Subject: AP1000 COL Response to Requests for Additional Information (TR 3)

RAI Response Number: RAI-TR03-015

AP1000 TECHNICAL REPORT REVIEW

Figure C-1 – FRS Comparison at Base of SCV on CIS at RPV Center

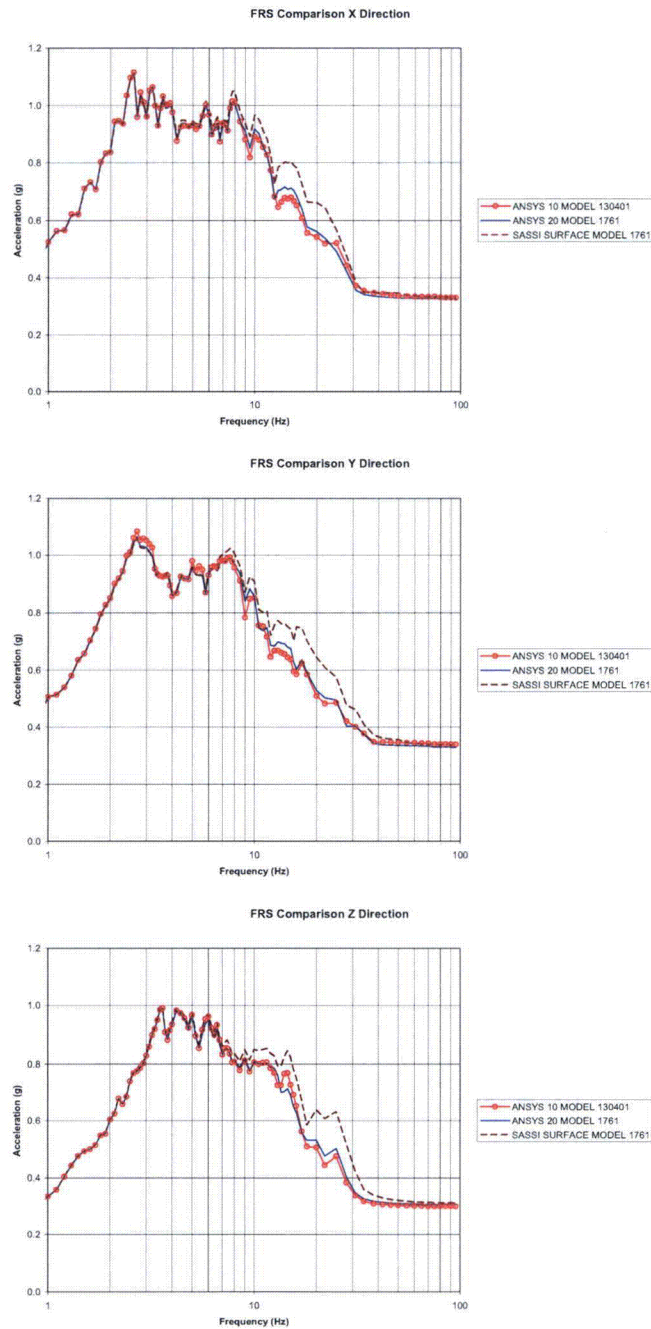
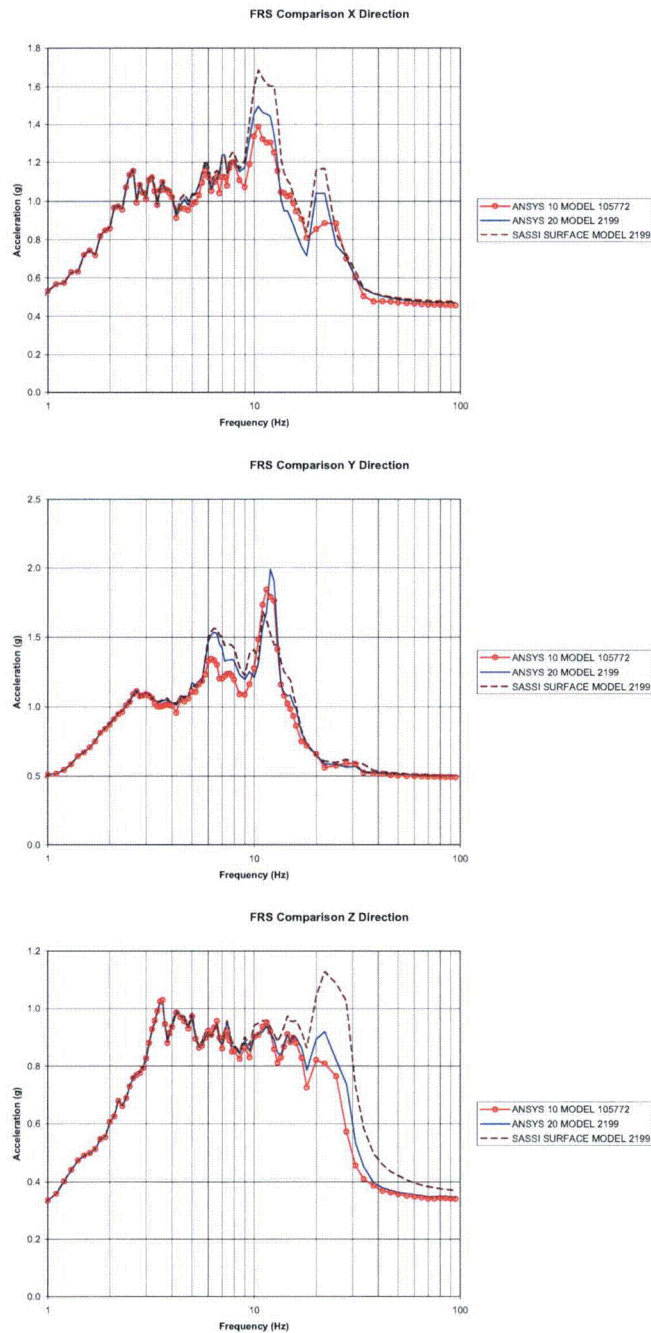
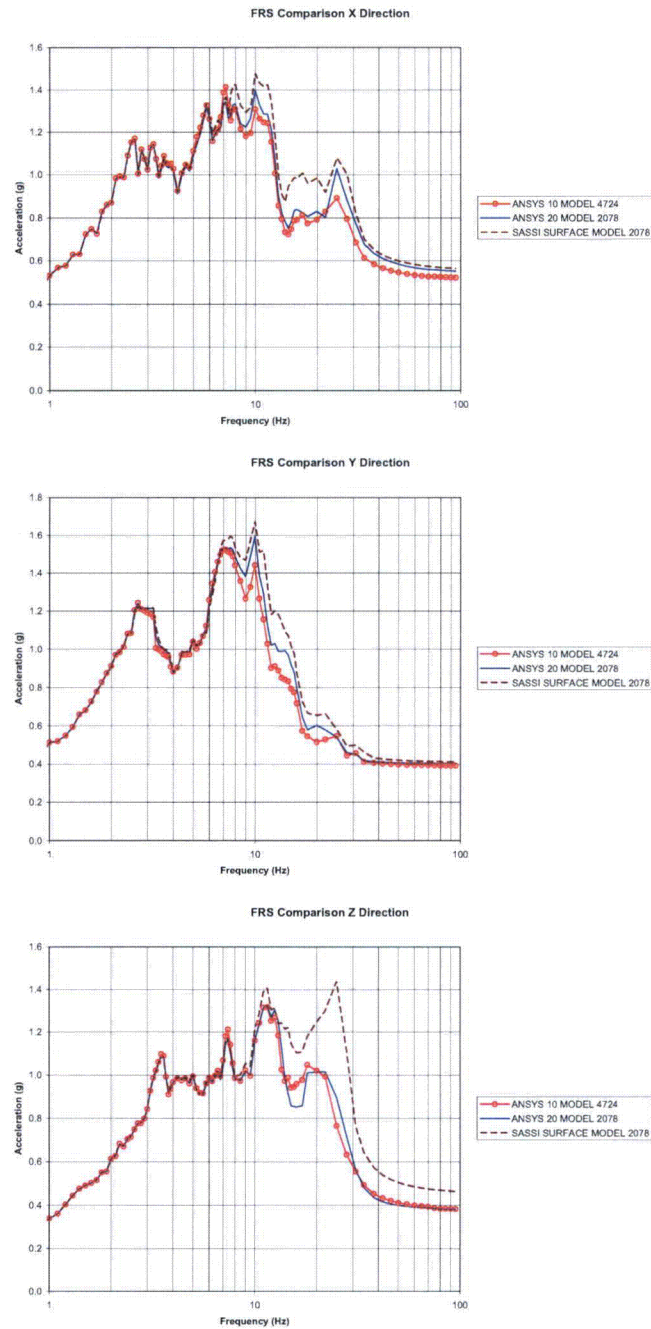
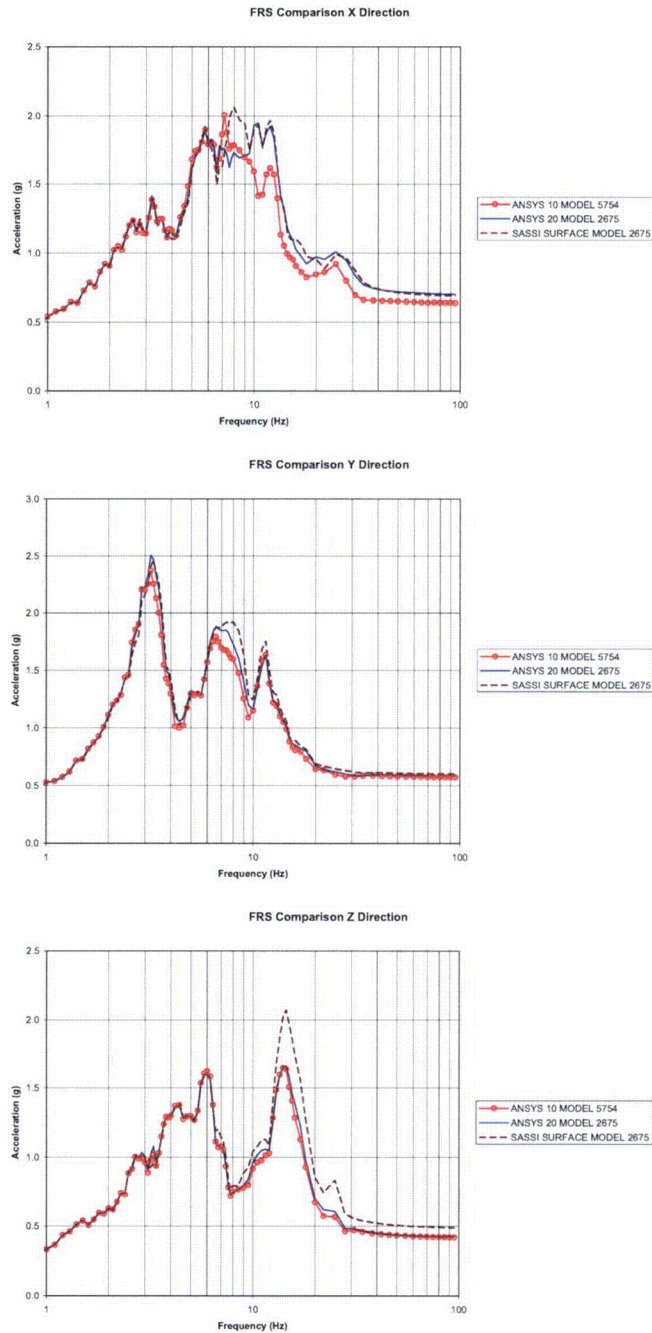
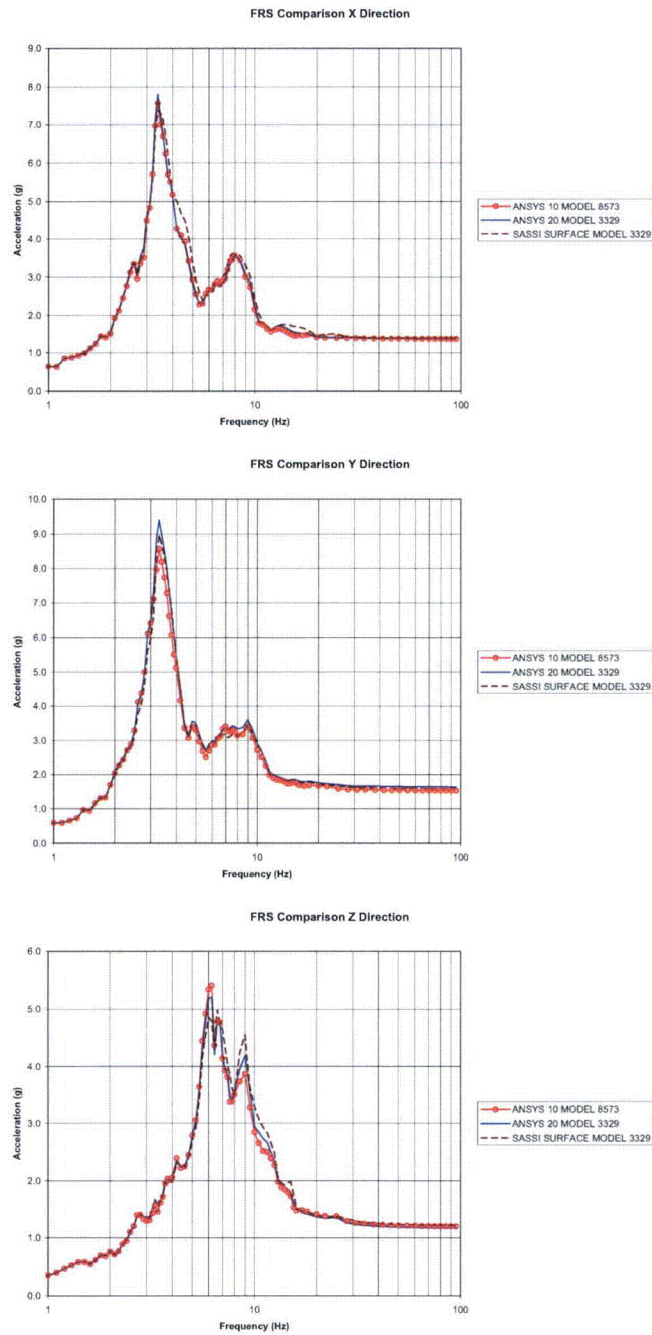
- c. Explain what studies were performed to establish that the NI10 model refinement is sufficient to accurately account for high frequency response effects at all critical locations. It is not obvious from the results shown in Figure C-1 that convergence with element size has been achieved.

Figures C-1 to C-6 compare response spectra for ANSYS analyses of the NI10 and NI20 models at the interface seismic response key nodes (see Section 4.4.3). These locations are given in Table C-1. Also shown in this table are the figures where the comparison spectra are given. Both finite element models give comparable results below 10 hertz. However, the results from the coarse model are not as good at high frequencies (above about 15 hertz). Therefore the hard rock FRS were generated from the fine NI10 model, and the coarse NI20 model was used for the soil site analyses where frequencies of interest are below 10 hertz.

As seen from the comparison (see Figures C-1 to C-6), for the horizontal response, the SASSI and ANSYS results for NI20 are very similar to about 15 Hz horizontal and about 10 Hz vertical. At the higher frequencies SASSI calculates higher accelerations. The NI20 model uses solid elements for the mass concrete below grade inside the shield building. Other parts of the model use shell elements. The difference in ANSYS and SASSI results is most noticeable at the three
